WATER DISTRIBUTION SYSTEM **AS-BUILT PLANS**

BAALMANN 5TH ADDITION - PHASE 1

CITY OF WICHITA, KANSAS

As-Built By: James Ralston &
Larry Powell
As-Built Date: 9-18-2025

FIRE HYDRANTS REQUIRED

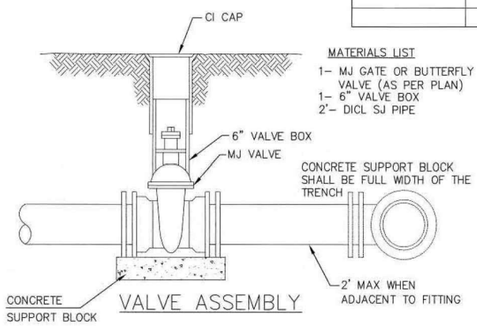
BURY LINE ELEVATION	STATION	BURY LINE ELEVATION	TOP OF PIPE ELEVATION	FIRE HYDRANT BURY REQUIRED*	VALVE STEM EXT. REQUIRED (ft)*	HYDRANT BARREL EXTENSTION
1328.26	Sta. 2+36.13, Line 1	~~1328.30~~	1323.95	5.0'	No	No
1330.14	Sta. 9+40.90, Line 1	~~1330.20~~	1325.85	5.0'	No	No
1328.10	Sta. 4+22.04, Line 2	~~1328.30~~	1324.45	4.5'	No	No
1327.89	Sta. 2+10.85, Line 4	~~1327.75~~	1323.40	5.0'	No	No

LINE 1

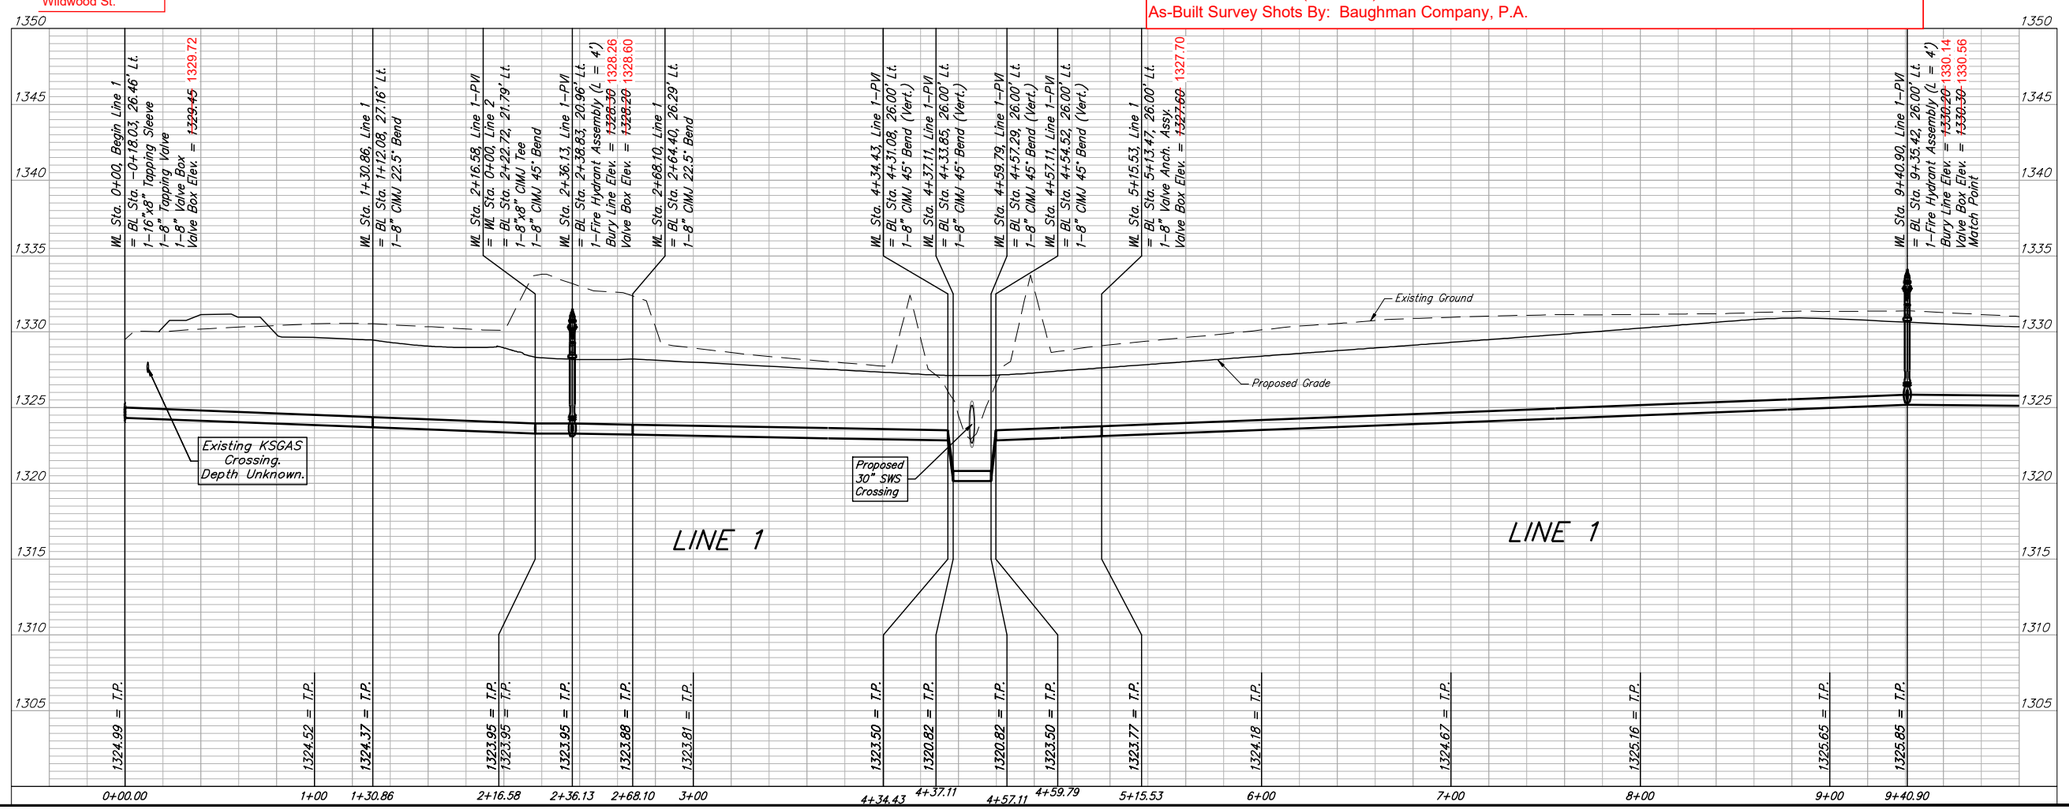
WL Sta. 2+36.13, Line 1
= BL Sta. 2+38.83, 20.96' Lt.
1–Fire Hydrant Assembly (L = 4')
Bury Line Elev. = ~~1328.30~~ 1328.26
Valve Box Elev. = ~~1328.20~~ 1328.60

WL Sta. 5+15.53, Line 1–PCC
= BL Sta. 5+13.47, 26.00' Lt.
1–8" Valve Anch. Assy.
Valve Box Elev. = ~~1327.60~~ 1327.70

WL Sta. 9+40.90, Line 1
= BL Sta. 9+35.42, 26.00' Lt.
1–Fire Hydrant Assembly (L = 4')
Bury Line Elev. = ~~1330.20~~ 1330.14
Valve Box Elev. = ~~1330.30~~ 1330.56
Match Point

WL Sta. 0+00, Begin Line 1
= BL Sta. −0+18.03, 26.46' Lt.
Tap Existing 16" Water Main.
To Be Furnished and Installed
By the City of Wichita Water Dept.
Verify Depth and Location of
Existing 16" Water Line Prior
to Construction.
1–16"x8" Tapping Sleeve
1–8" Tapping Valve
1–8" Valve Box
Valve Box Elev. = ~~1329.45~~ 1329.72

LINE 1 (2)

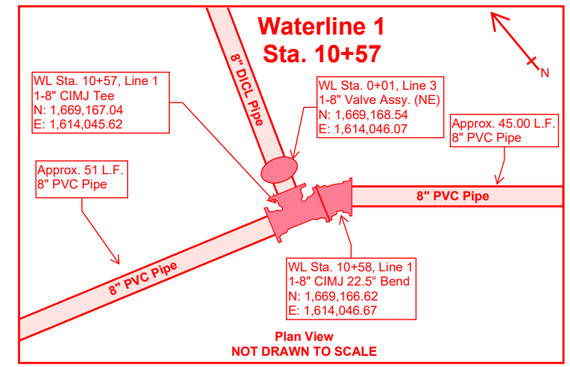
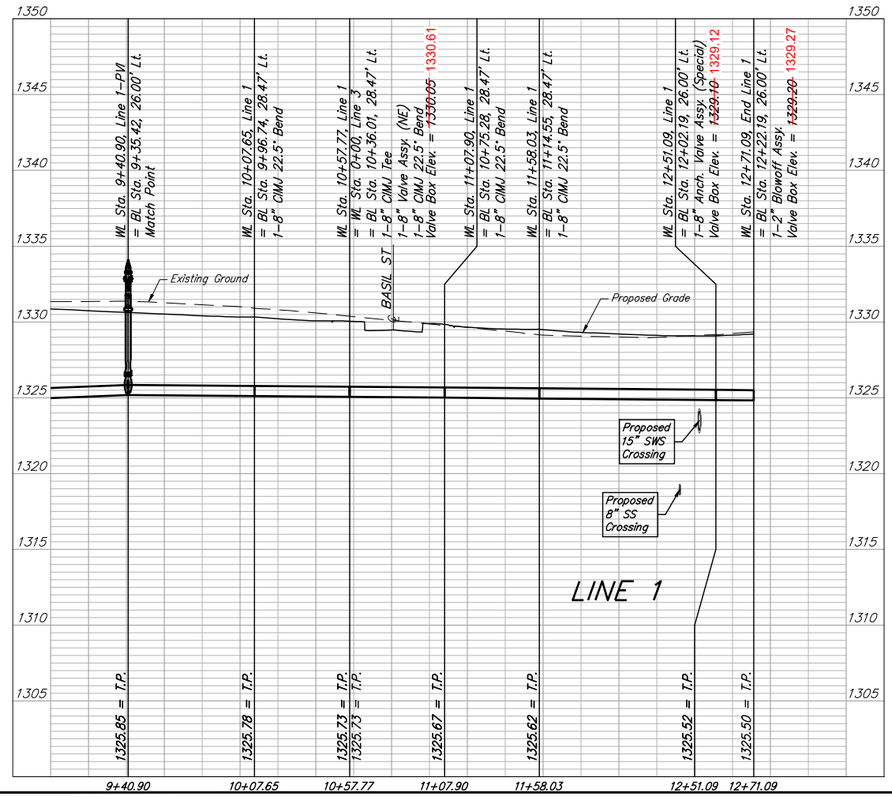
45 L.F. ~~50.13~~ L.F. 8" Pipe

WL Sta. 10+57.77, Line 1
= WL Sta. 0+00, Line 3
= BL Sta. 10+36.01, 28.47' Lt.
1–8" CIMJ Tee
1–8" Valve Assy. (NE)
1–8" CIMJ 22.5° Bend
Valve Box Elev. = ~~1330.05~~ 1330.61

51 L.F. ~~50.13~~ L.F. 8" Pipe

WL Sta. 12+51.09, Line 1
= BL Sta. 12+02.19, 26.00' Lt.
1–8" Anch. Valve Assy. (Special)
Valve Box Elev. = ~~1329.10~~ 1329.12

WL Sta. 12+71.09, End Line 1
= BL Sta. 12+22.19, 26.00' Lt.
1–2" Blowoff Assy.
Valve Box Elev. = ~~1329.20~~ 1329.27

LINE 2

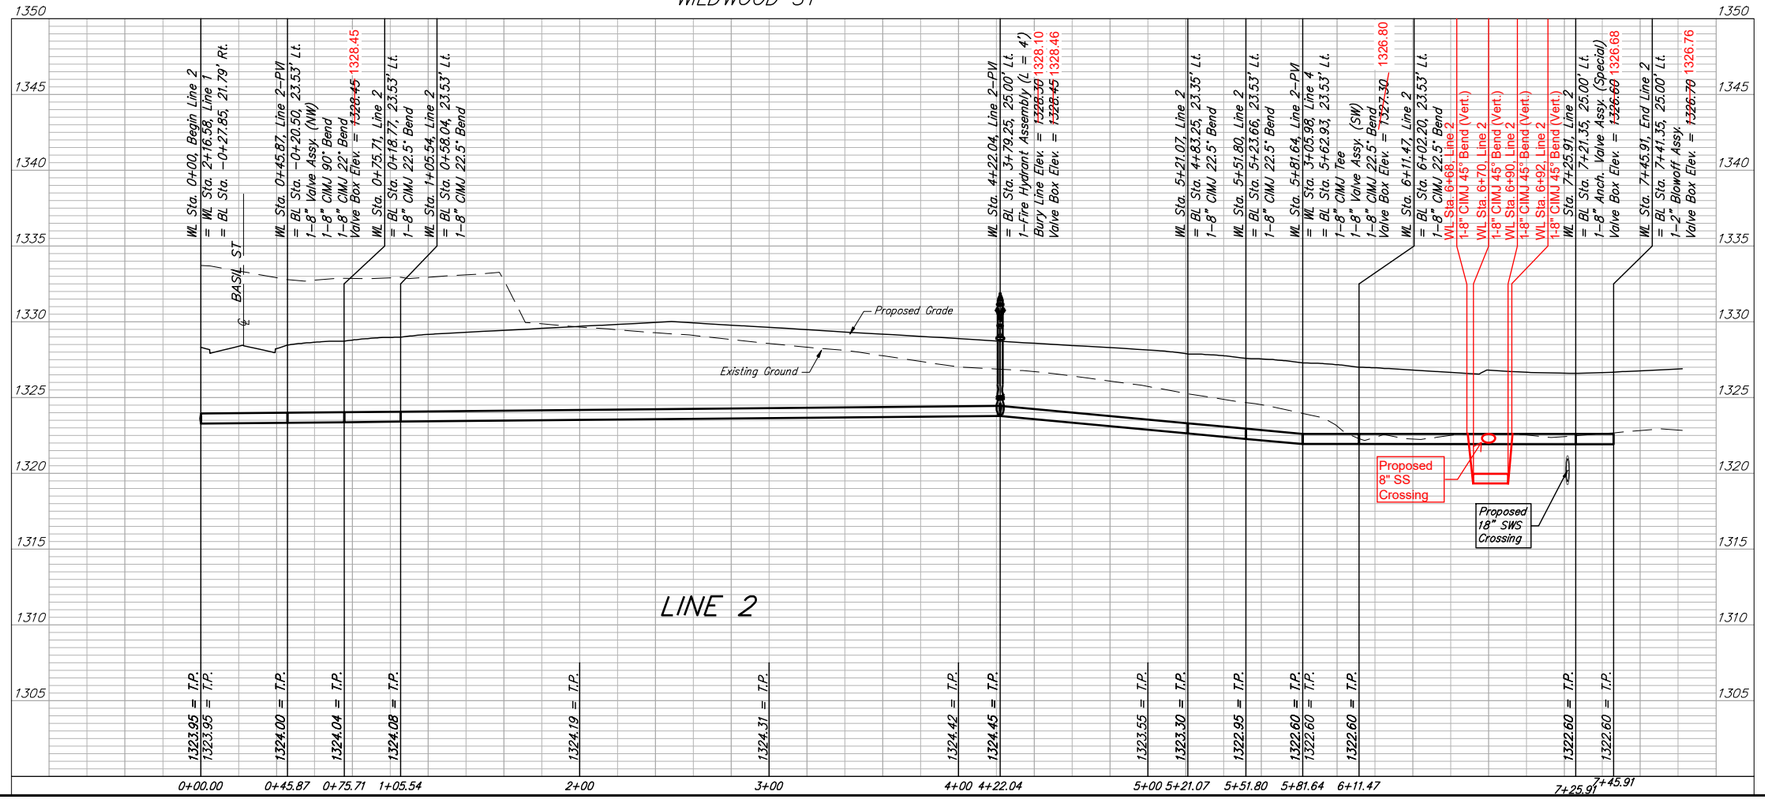
WL Sta. 5+81.64, Line 2
= WL Sta. 3+05.98, Line 4
= BL Sta. 5+62.93, 23.53' Lt.
1-8" CIMJ Tee
1-8" Valve Assy. (SW)
1-8" CIMJ 22.5° Bend
Valve Box Elev. = ~~1327.30~~ 1326.80

WL Sta. 7+45.91, End Line 2
= BL Sta. 7+41.35, 25.00' Lt.
1-2" Blowoff Assy.
Valve Box Elev. = ~~1326.70~~ 1326.76

WL Sta. 0+45.87, Line 2
= BL Sta. -0+20.50, 23.53' Lt.
1-8" Valve Assy. (NW)
1-8" CIMJ 90° Bend
1-8" CIMJ 22° Bend
Valve Box Elev. = ~~1328.45~~ 1328.45

WL Sta. 4+22.04, Line 2
= BL Sta. 3+79.25, 25.00' Lt.
1-Fire Hydrant Assembly (L = 4')
Bury Line Elev. = ~~1328.30~~ 1328.10
Valve Box Elev. = ~~1328.45~~ 1328.46

WL Sta. 7+25.91, Line 2
= BL Sta. 7+21.35, 25.00' Lt.
1-8" Anch. Valve Assy. (Special)
Valve Box Elev. = ~~1326.60~~ 1326.68

~~114.43 L.F.~~ 8" Pipe
57 L.F.

LINE 3

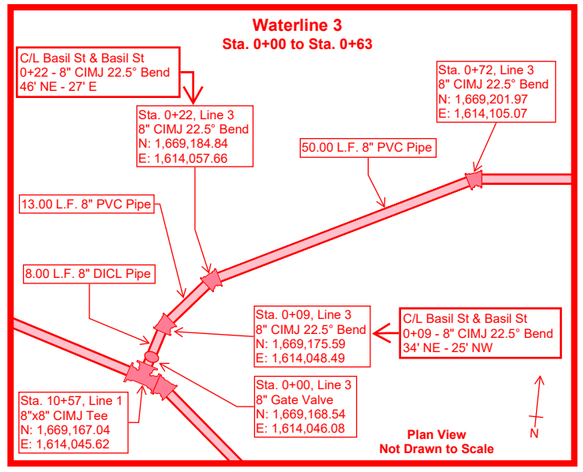
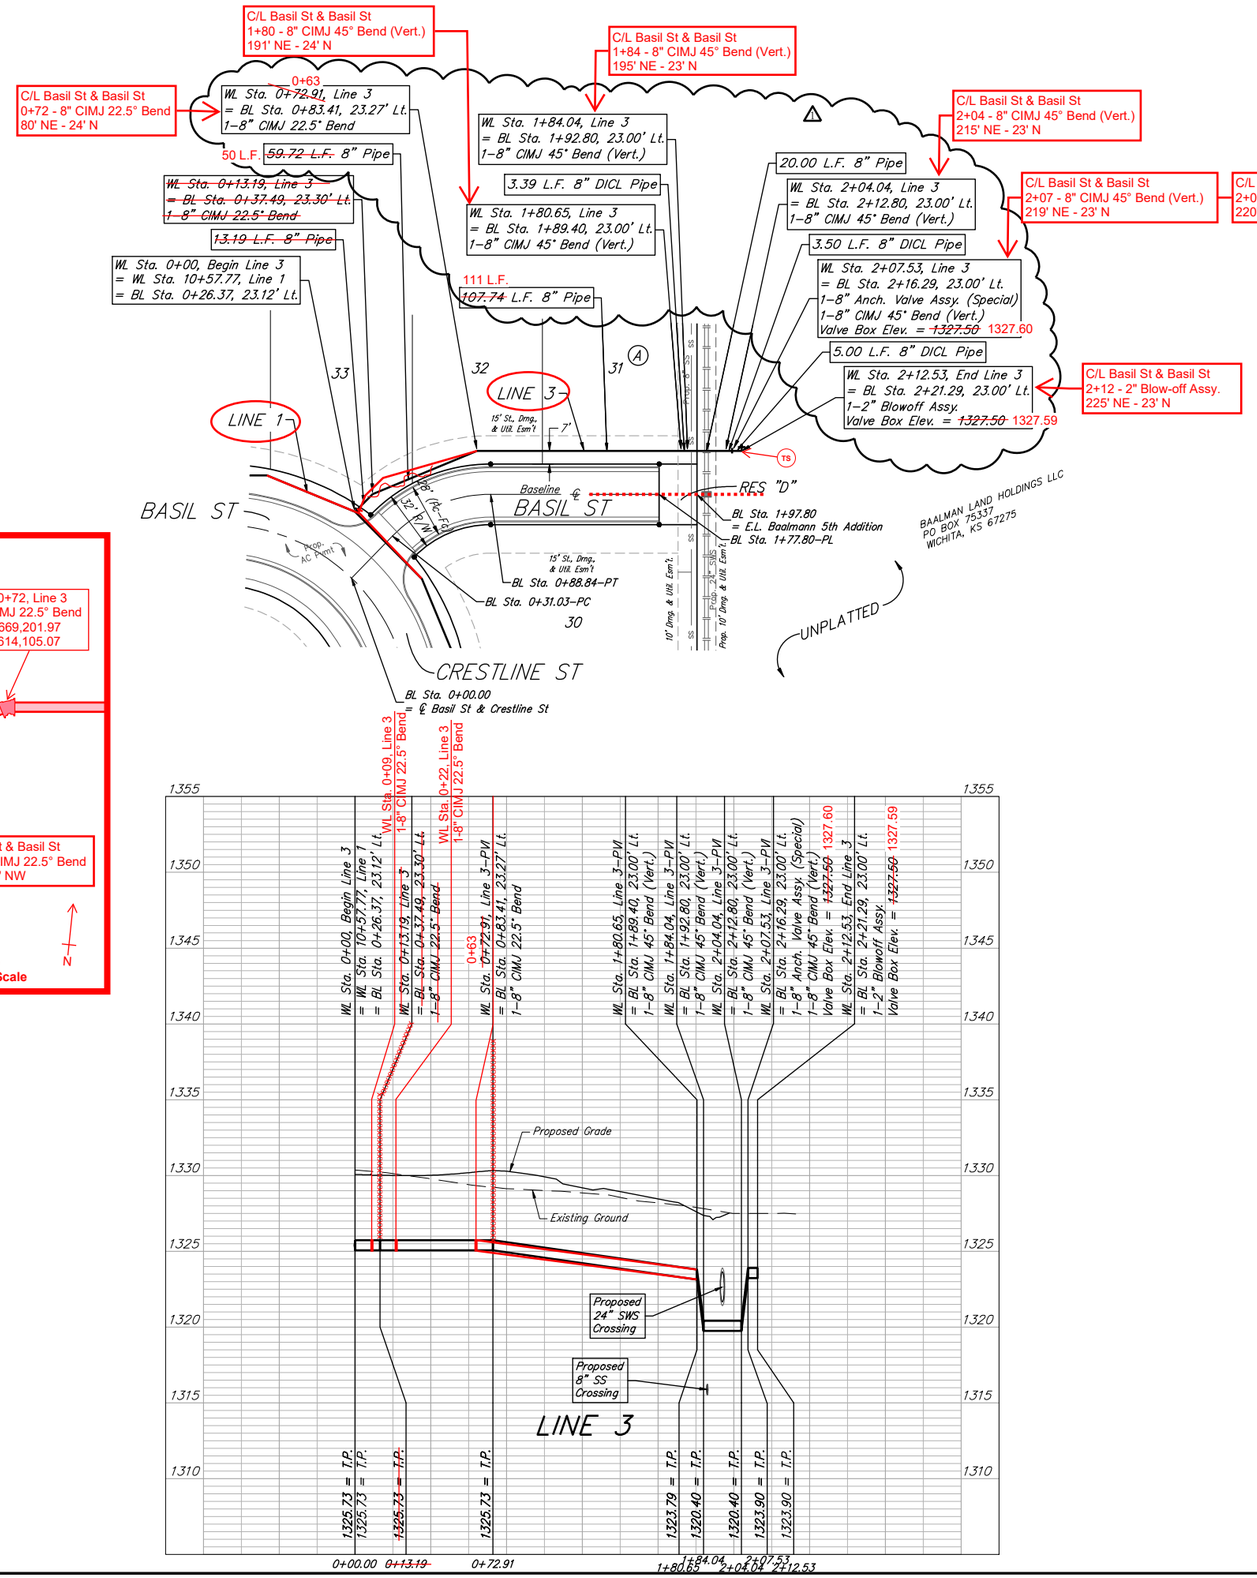
REVISIONS:
Extended Water Line to Cross Proposed Utilities
